BICYCLE AND PEDESTRIAN FACILITY TYPICAL SECTION

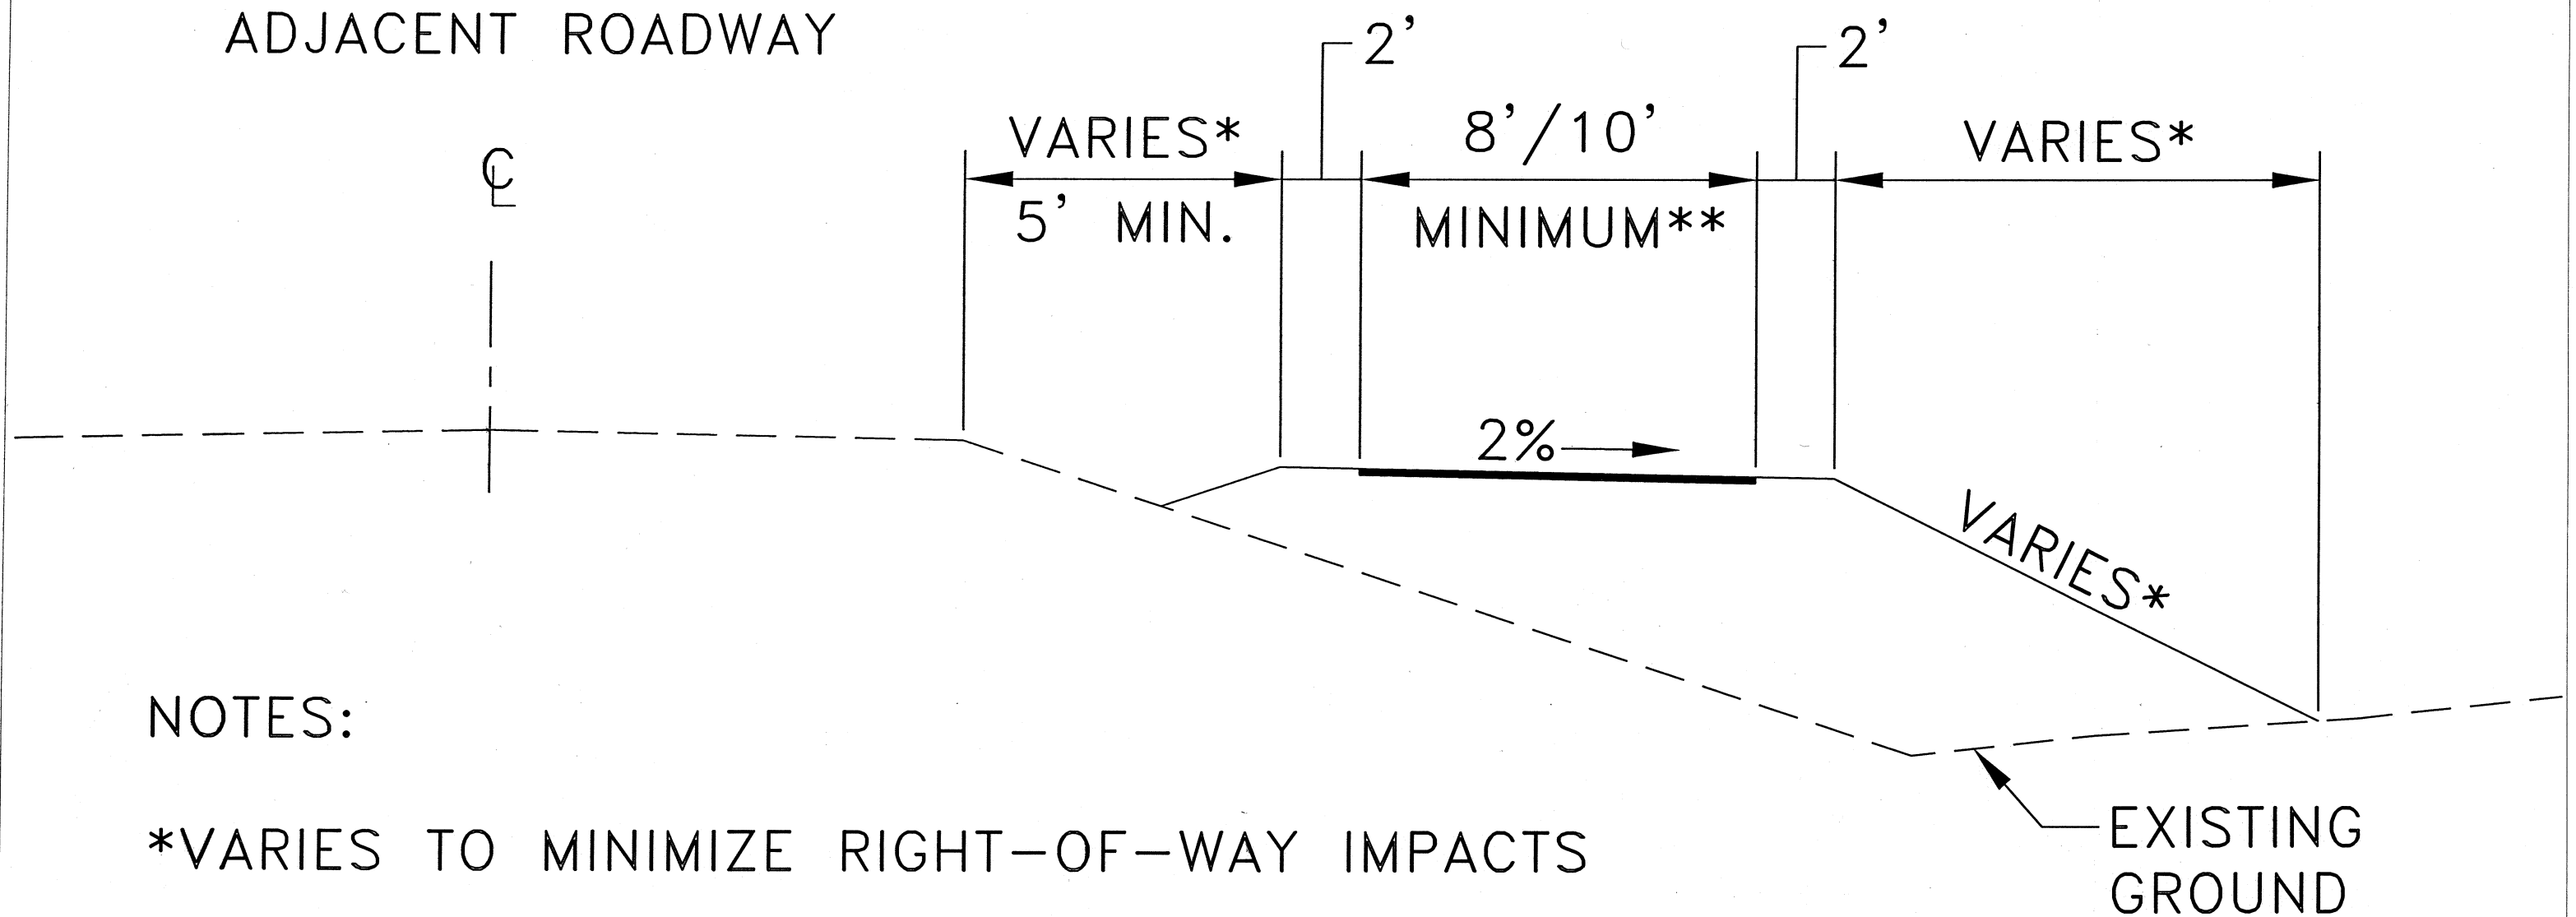
**PENDING — WHAT WILL YOU USE IT FOR?
